H. B. ROBINSON STEAM ELECTRIC PLANT, UNIT NO. 2
DOCKET NO. 50-261/RENEWED LICENSE NO. DPR-23

**H. B. ROBINSON STEAM ELECTRIC PLANT, UNIT NO. 2 - REQUEST FOR ADDITIONAL
INFORMATION REGARDING APPLICATION TO REVISE TECHNICAL SPECIFICATION
SURVEILLANCE REQUIREMENT FREQUENCIES TO SUPPORT 24-MONTH FUEL CYCLES**

**RESPONSE TO NRC REQUEST FOR ADDITIONAL INFORMATION REGARDING
TECHNICAL SPECIFICATION SURVEILLANCE REQUIREMENT FREQUENCIES TO
SUPPORT 24-MONTH FUEL CYCLES (RAI EICB-1 THROUGH EICB-19)**

Figure 7: Typical Voltages vs. Minimum Frequency Curves 60 Hertz KF Underfrequency Relay

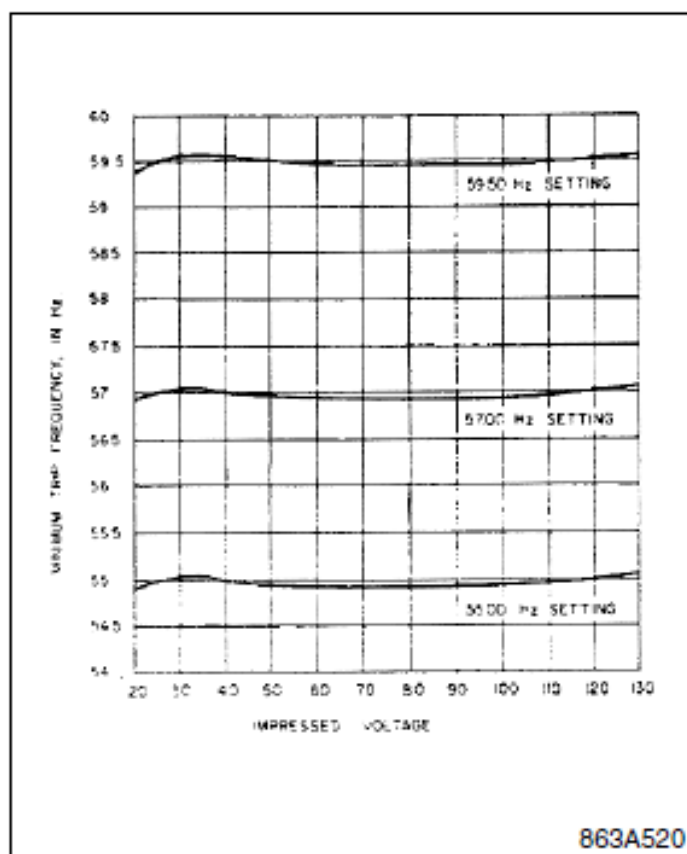
The licensee states that there were two failures of relay 811/1 after replacement and one failure of relay 811/2 after it was replaced in 2007. Please explain if failure means exceeded the "as-found tolerance" per the licensee acceptance criteria or something else. If some other acceptance criteria is used then please describe and justify the use of the alternate acceptance criteria. In addition, please describe what steps are taken by plant operating procedures to ensure that the relay failures are adequately evaluated and necessary steps are taken to ensure that the relays continue to operate in an acceptable manner without jeopardizing future safe operation of these relays.

The RCP Underfrequency (UF) relays are Westinghouse type KF underfrequency relays. The calibration of these relays is based on Westinghouse Installation, Operation, and Maintenance Instructions I.L. 41-503F, effective May 1968. The voltage versus frequency setpoint response is relatively flat between 120VAC and 40VAC as shown below:

The vendor maintenance instructions include verification that the frequency trip setpoint is between 0.06Hz and 0.08Hz above the desired trip frequency when the applied voltage is reduced from 120VAC to 40VAC. This verification of frequency trip point over varying voltages (120VAC and 40VAC) is referred to in the discussion below as consistency of trip setpoint. RNP Calibration Procedure PIC-806, Westinghouse Type KF Underfrequency Relay, provides a desired trip setpoint of 58.20Hz for 120VAC applied voltage, with a tolerance of 58.00Hz to 58.40Hz. At the 40VAC applied voltage, the desired trip setpoint is 0.07Hz greater than the 120VAC frequency setpoint, and a tolerance of 0.060Hz to 0.080Hz above the 120VAC frequency setpoint.

RNP Technical Specifications Table 3.3.1-1, Item 12, provides a Nominal Trip Setpoint of 58.2Hz, and an Allowable Value of greater than or equal to 57.84Hz. The Allowable Value is applied for the evaluation of calibration as-found data to determine whether the instrument drift exceeded acceptable limits.
